Service Bulletin

Product	Laser Disk Player
Number	B10-92-6
Date	June 1992

Panasonic LX-1000U, LX-200U

Subject: Video Cross-Talk Problem.

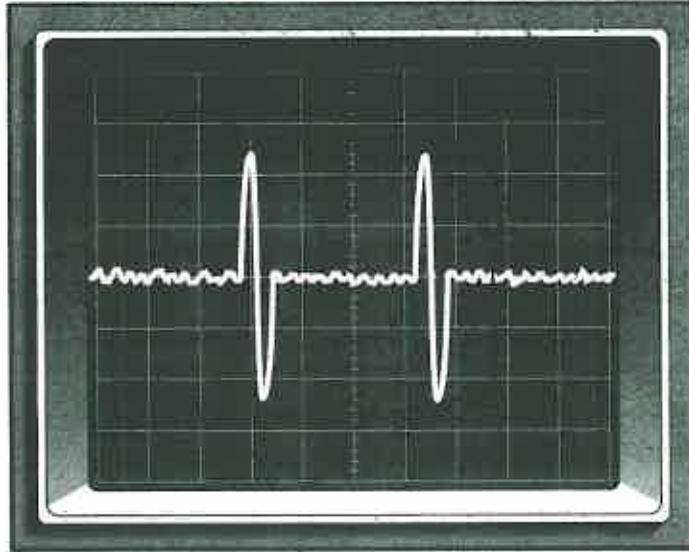
Cause: For various reasons, the Optical Pick-up Unit (OPU) is picking up undesired video signal from the adjacent track along with the desired signal from proper track, resulting in interference between them.

1. Perform adjustment item 1-4 and 1-5 of Service Manual of Tilt Balance VR22301 and VR22302.

(2-3) Adjust VR22301 to maximize spike of Tracking Error signal(T.E.).

(2-5) Adjust VR22302 to maximize spike of T.E. signal.

3. If Cross-talk beat still persists, replace the OPU (New Part #SOAD90A) and perform all Servo adjustments (Focus and Tracking servos).
If necessary, perform steps (2-1) through (2-5) as above.
